Submission for Job: #5878 SSD 5878-2013 Sydney International Convention, Exhibition and Entertainment Centre
 Precinct - Mixed use Development in the Southern Haymarket Precinct (Concept Proposal)
https://majorprojects.affinitylive.com?action=view_job&id=5878

EIS Errors

Group submission relating to application SSD 5878

7428A MCD AR D307 01/03/2013 1:1000 @ A3	DENTON CORKER MARSHALL	THE HAYMARKET LEND LEASE DEVELOPMENT	DEVELOPMENT APPLICATION PEAK TOWER - NORTH ELEVATION PROPOSED BUILDING PROFILE OVER
---	------------------------------	---	---

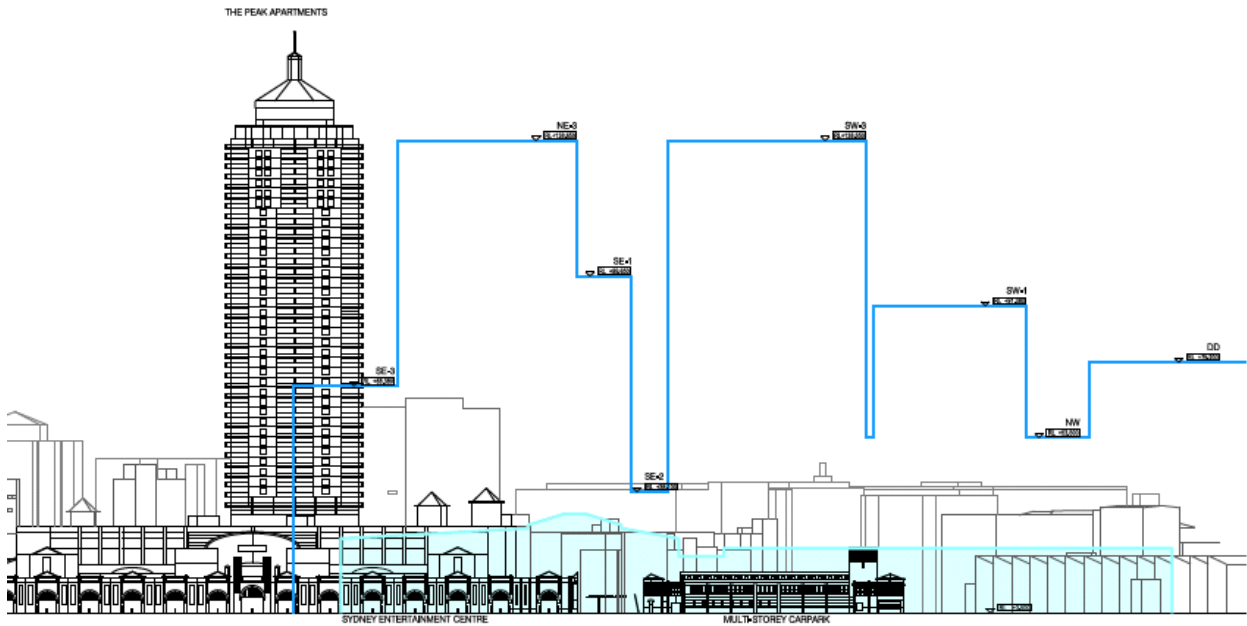
The following figure – buried in SSD 5755 illustrates the size of the proposal in relation to The Peak.

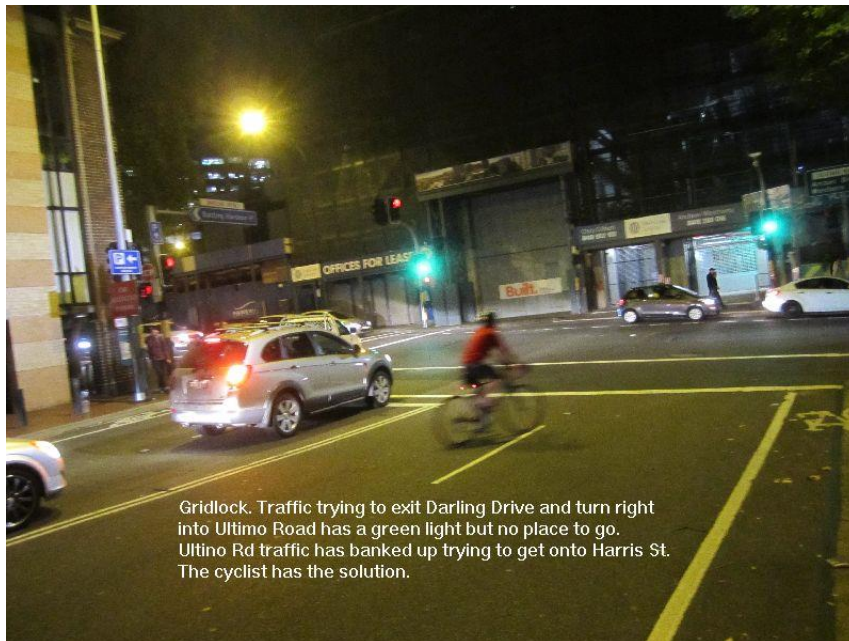
4. **The traffic studies do not include one of the three exit/entry points to Darling Drive, that being Ultimo Rd, the key to traffic movement for the PPP and the PDA.**

Darling Drive has three access points:

- Ultimo Road at the south end
- Harbour St (Pier St) in the middle
- Union Street/Murray Street at the north end

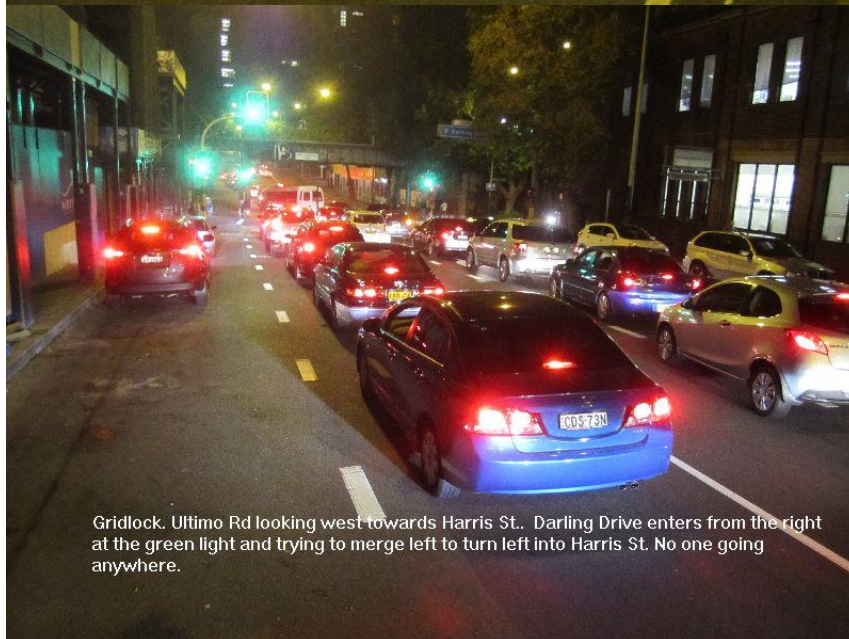
Gridlock. Traffic trying to exit Darling Drive and turn right into Ultimo Road has a green light but no place to go. Ultimo Rd traffic has banked up trying to get onto Harris St. The cyclist has the solution.

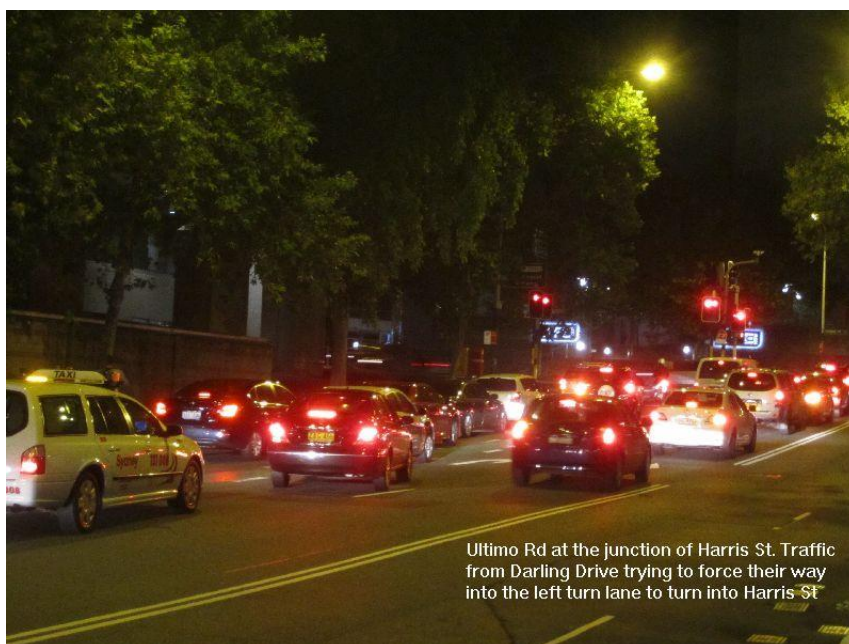
Gridlock. Ultimo Rd looking west towards Harris St.. Darling Drive enters from the right at the green light and trying to merge left to turn left into Harris St. No one going anywhere.

Peak Level 42

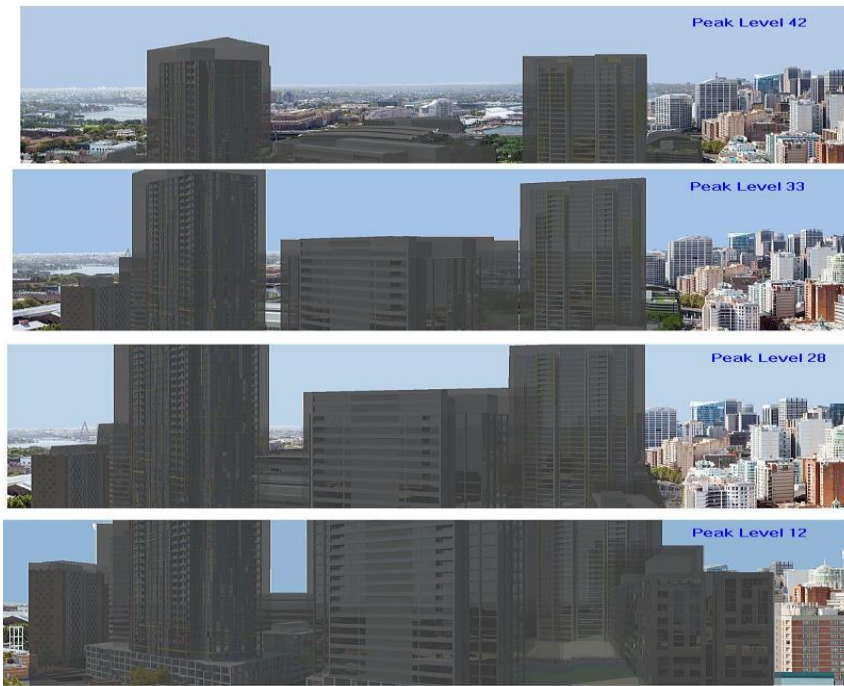
DMC acknowledge and restate those principles (Design Report p 50) and add that *“Towers are to be slender in form and should not come to the ground, but rise from urban blocks”* and then design virtually every tower originating with a sheer wall from the street !

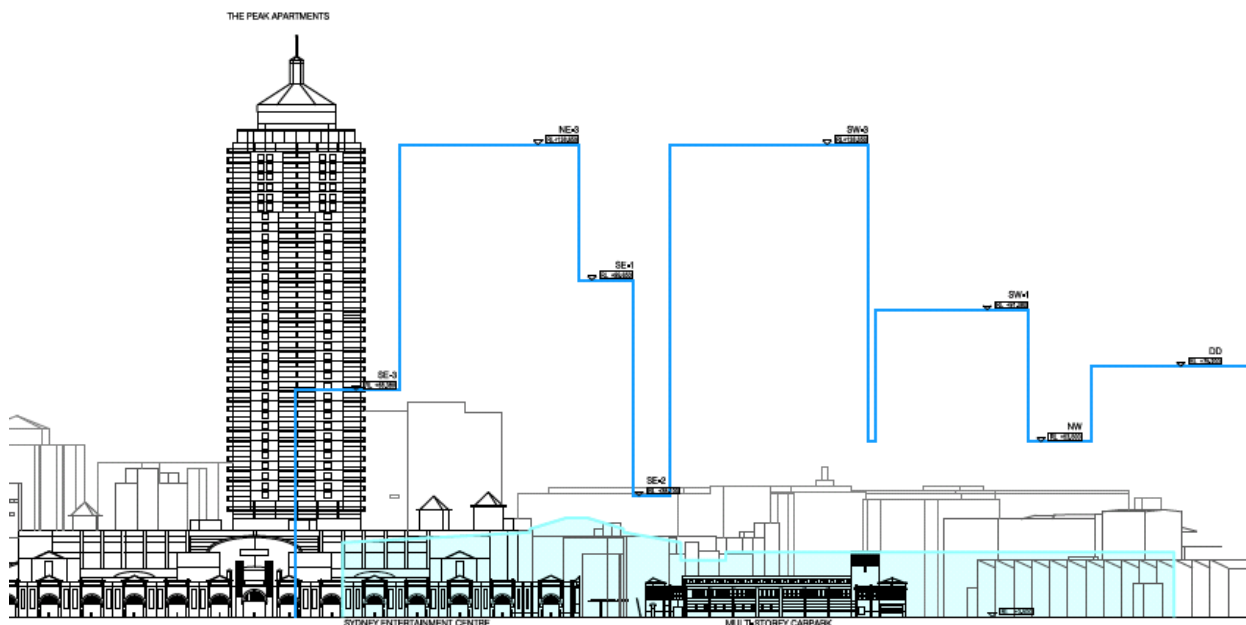
This shows these planning guidelines have been ignored in the drive for increased density and optimum placement of the new towers for maximum return - all with scant regard for the existing buildings.

The loss of amenities, outlook and views is an excessive burden on the residents of the Peak and for all the residents of surrounding buildings. At a minimum, it is imperative to delete the Tower SE1 from the planned development.

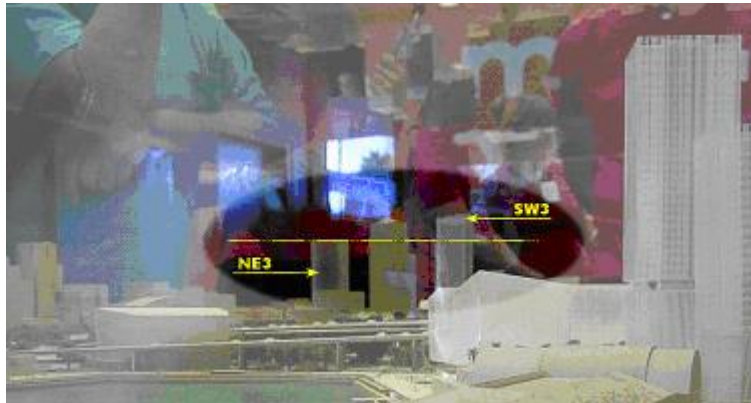
The student blocks and tower SW 1 will obscure the sight lines to the Museum from the southwest and the CBD. Why is it deemed sufficient to retain only the western façade when the eastern façade is the most important one.

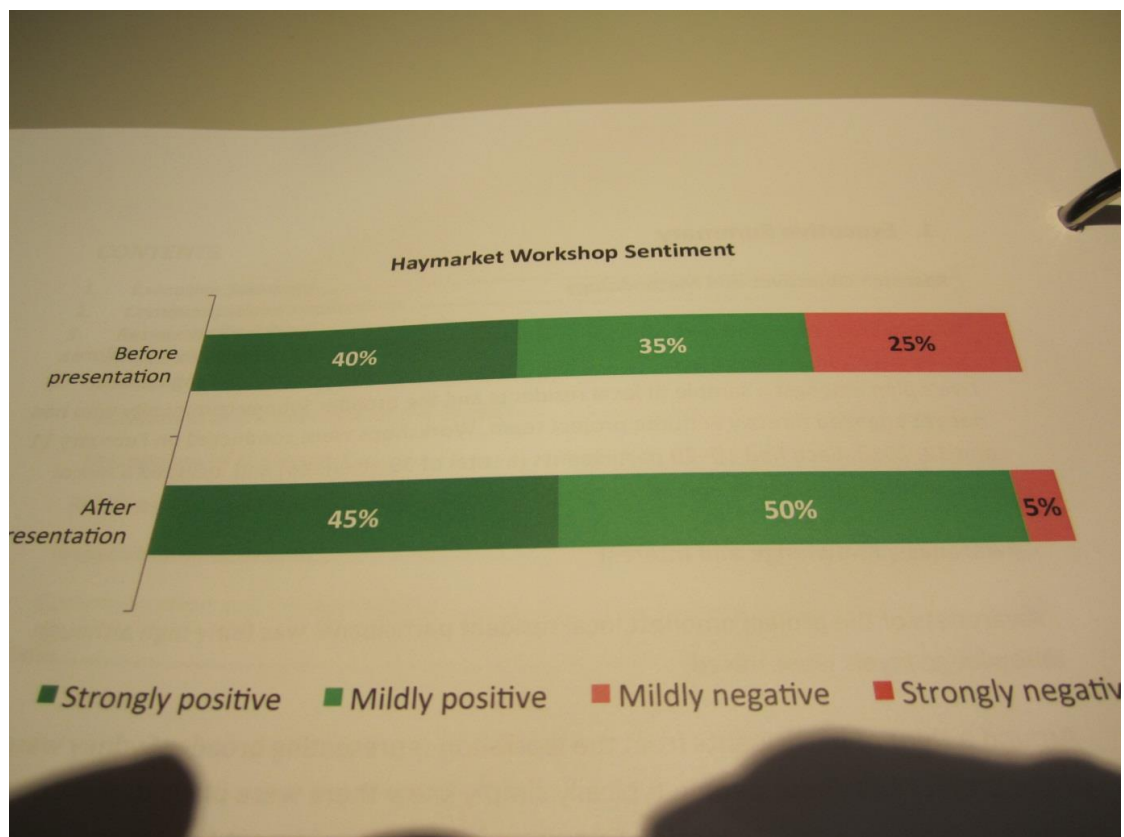
The information given during consultation was very much smoke and mirrors. The statements given on the height of the towers was vague and variable with the number of floors being defined from the podium level in some cases. The RLs of the top of the towers were not disclosed prior to the EIS being lodged. In fact tower NE3 grew about 8 floors after consultation. This is clear from photos of the original model.

It is claimed that ‘mildly negative sentiment after presentations was reduced by 20%.’ This is not the impression of those who attended the meeting. Many walked out in disgust when it was fairly blatantly put to them that this was the deal and you could have your say when the DA was posted.
